No. EL/11.5.5/6

**MODIFICATION SHEET NO. RDSO/2022/EL/MS/486 (Rev. '1')**

Modification to ensure continuity of HOG Converters' feed to the train from working loco through dead loco in WAP5/WAP7 class of 3-phase HOG compliant electric locomotives.

**Figure – 2: Infringement of loco body to the Ratchet Grip**

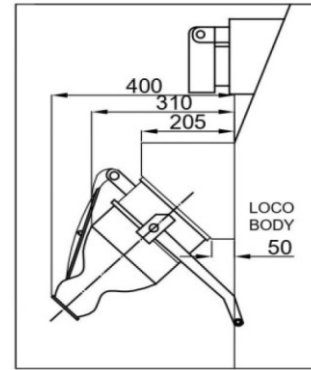
- 2.4** During 40<sup>th</sup> MSG meeting, Zonal Railways had pointed out the infringement issue of the ratchet handle of IV Coupler with the cab/loco body due to the shorter base dimension (50mm) given in drawing no. CDD-HL-P73-085 (Alt. 2) of the housing box of IV coupler. It was recommended that infringement of the ratchet handle with the loco body may be avoided by introducing the older version of the drawing of IV Coupler Housing Box Assembly i.e. drawing no. CDD-HL-P73-085 (Alt. 1) wherein the box base has been shown as 100 mm.

No infringement with CLW Drawing No.  
CDD-HL-P73-085, Alt. 1

Infringement with CLW Drawing No.  
CDD-HL-P73-085, Alt. 2

**Figure – 3: Infringement of Plug Assembly with Power Car Body**

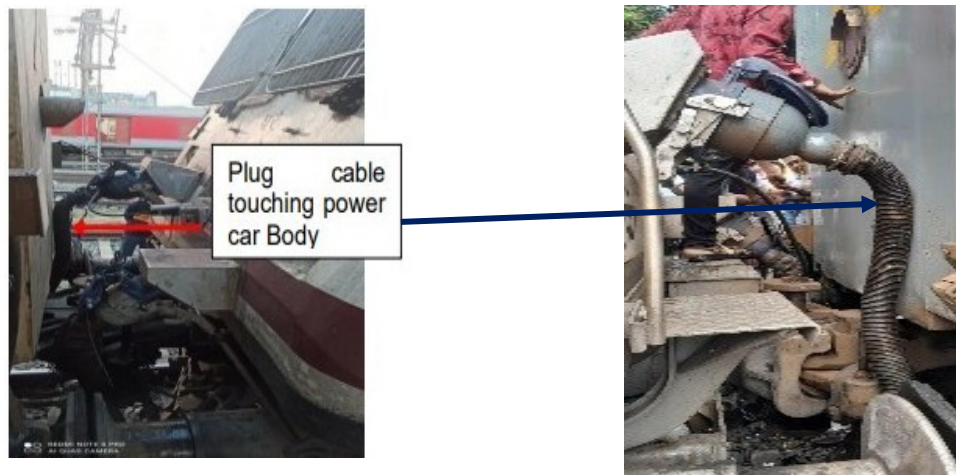
- 2.5** In this connection, the modification sheet was revised and draft of revised Modification Sheet No. RDSO/2022/EL/MS/486 (Rev. '1') was circulated to ZRs & PUs vide letter No. EL/11.5.5/6 dtd. 02.08.2023 for comments/suggestions.
- 2.6** In response to above, Western Railway vide letter No. EL 91/2/2/3(HLC) dtd. 24.08.2023 informed that after suggested modification, while attaching IV coupler from power car to loco in case of Upper side IV Coupler (ALP side), the plug assembly of coupler is touching with power car body and is likely to get damaged during the train movement. The photograph of infringement is as given in Figure-3.

- 2.7** In order to avoid the infringement of IV coupler jumper plug assembly to Power Car, IVC housing box was modified and Draft-2 of Modification Sheet No. RDSO/2022/EL/MS/486 (Rev. '1') was circulated to ZRs/Pus vide letter No. EL/11.5.5/6 dtd. 26.10.2023 for comments. WR & NR in their comments informed that the modified IV coupler socket works normally when connected to power car/LSLRD and there is no infringement of IV

**Figure – 4: Infringement of Plug Assembly with LP side IVC Housing Hinged Cover**

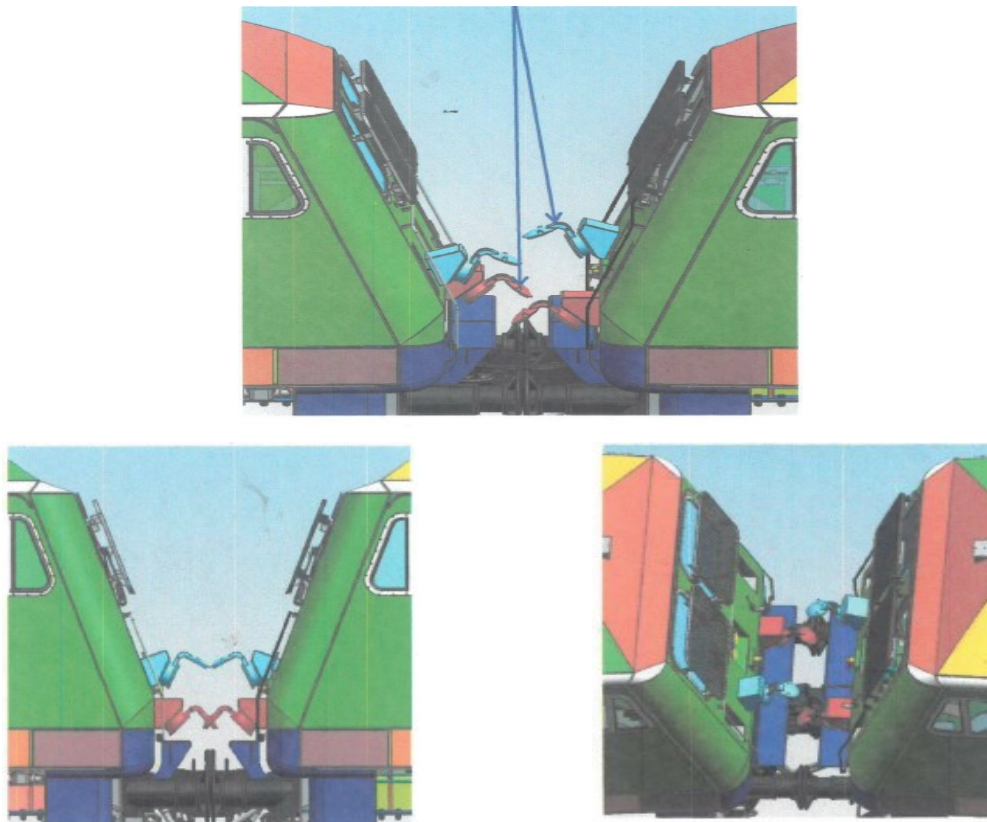
When two locos are connected back-to-back, ALP side IVC socket housing box of one loco will face LP side IVC socket housing box of the second loco. Since, the ALP side IVC socket housing box is shifted upward, the two facing IVC housing box (ALP & LP side) will not be at the same level. However, there is infringement of jumper plug cable (for loco-to-loco

connection) with hinged cover of LP side IV coupler housing box. The infringement may be seen in Figure-4 below.

To resolve the above issue, cable entry flange of existing plug may be provided at twisted angle to the extent which may permit the opening of hinged cover of the other loco.

**Figure – 5: Sketch of the IV Coupler Housing Box after modification**

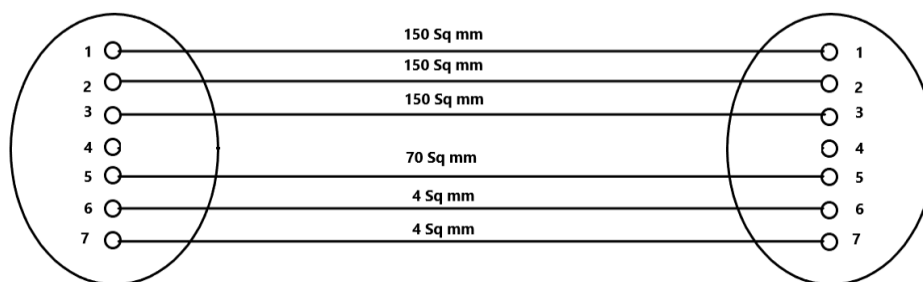
The scheme given below will be able to feed HLC power from leading loco to train through dead/trailing locomotive. Sketches of the two coupled locomotives with modified ALP side IV Coupler Housing Box have been shown in the Figure – 5 below.

**SKETCH of Modified Housing Box (Socket) for WAP5 Locomotives**

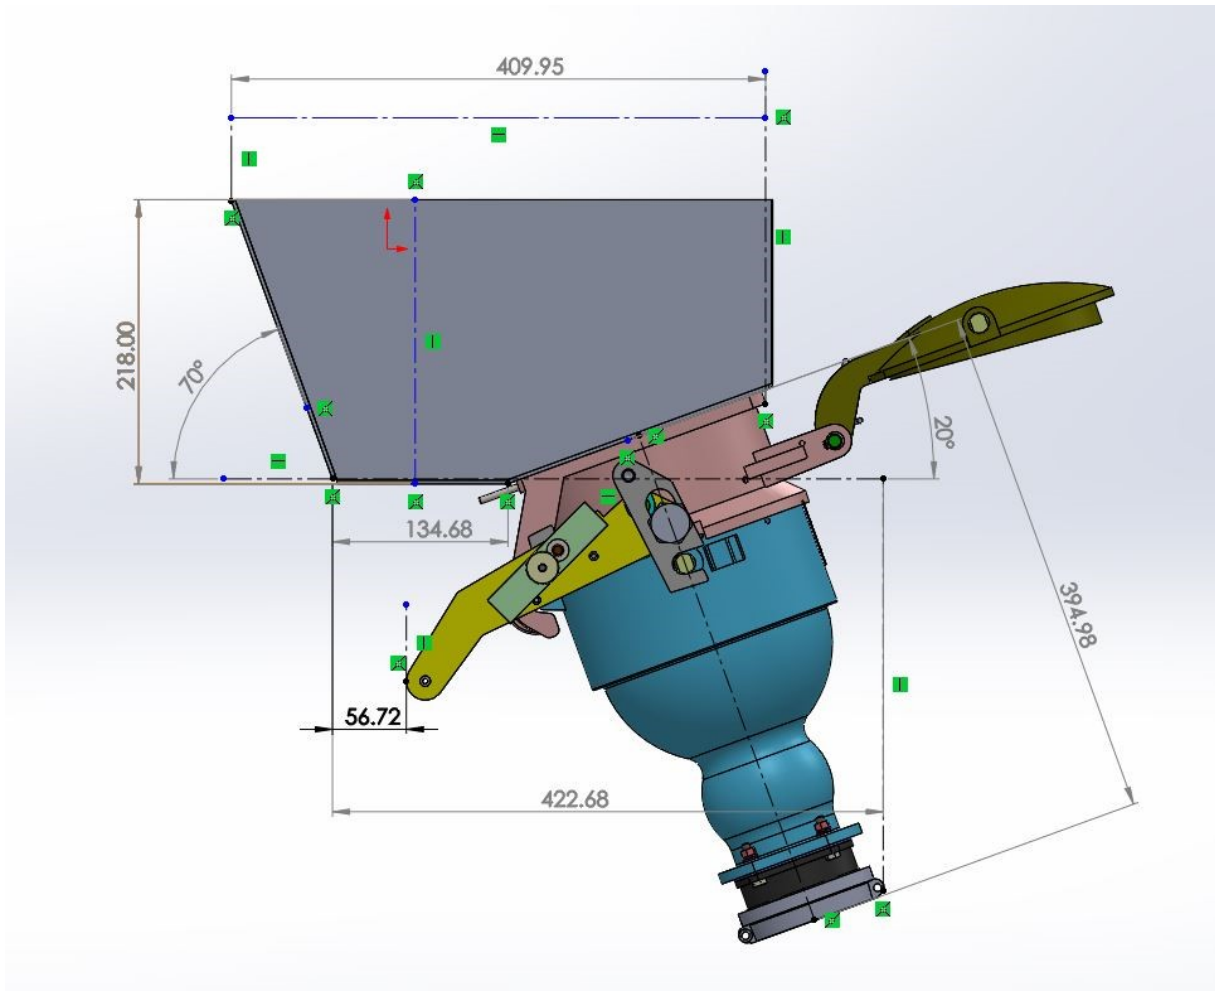
In view of above, ALP side IV Coupler Socket Housing Box for WAP5 and WAP7 loco shall be designed as per sketch given in Annexure-2 and Annexure-3 respectively. The ALP side IV Coupler Socket Housing Box shall be shifted upward as indicated in the CLW drawing No. SKETCH-28/01/22 enclosed as Annexure-1. LP side IV Coupler Socket Housing Box shall be retained at its original position.
